DESIGNED <i>DKC</i>	REVISED <i>Addendum A 5-23-12</i>
CHECKED <i>KMY</i>	REVISED -
DRAWN <i>CJM</i>	REVISED -
DATE <i>03/22/2012</i>	CHECKED <i>KMY</i>
	REVISED -

I & C CONTROL PANEL SCHEMATIC
PUMP STATION 47

SHEET NO. CPD-3 OF 4 SHEETS

CPD-3

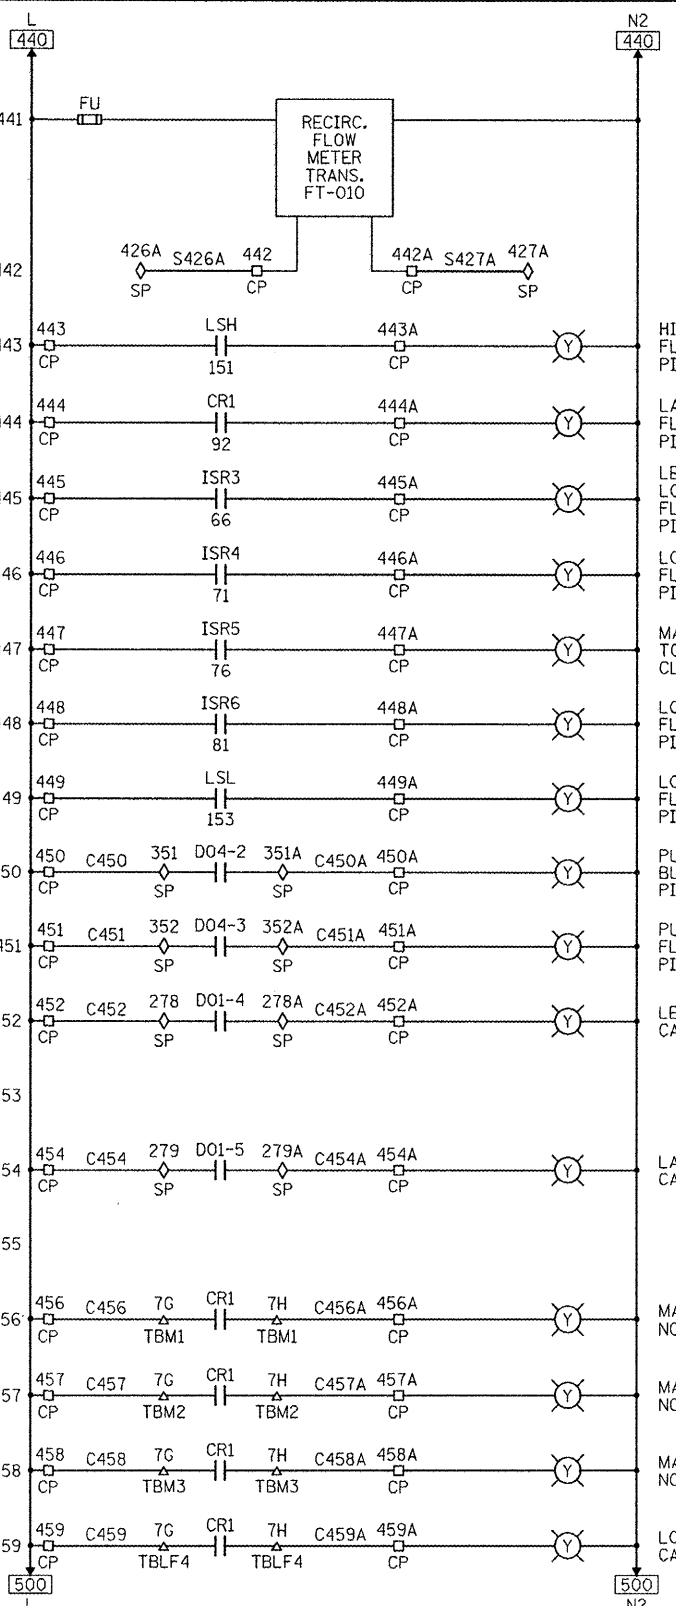
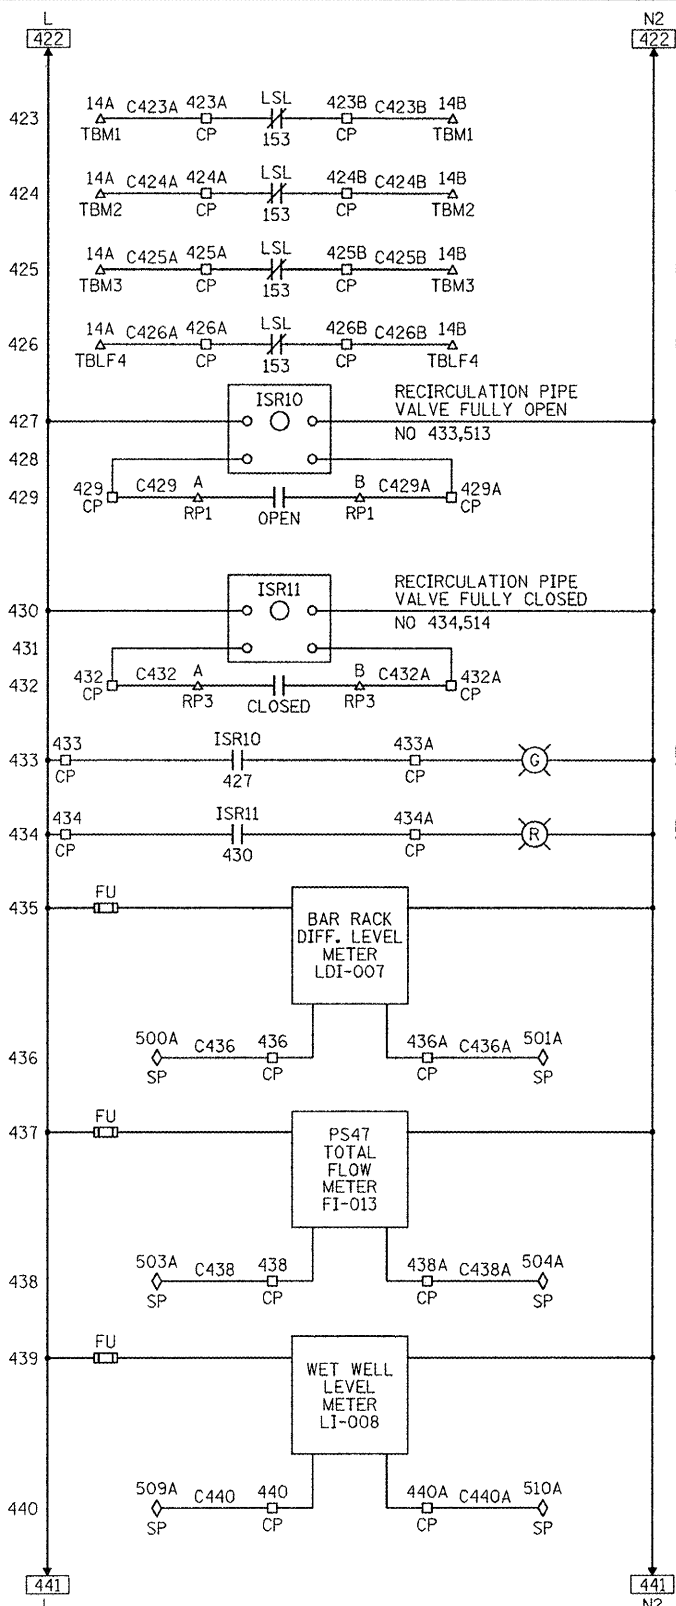
REFER TO RECIRCULATION PIPE VALVE RPV-1 DETAIL ON SHEET E10
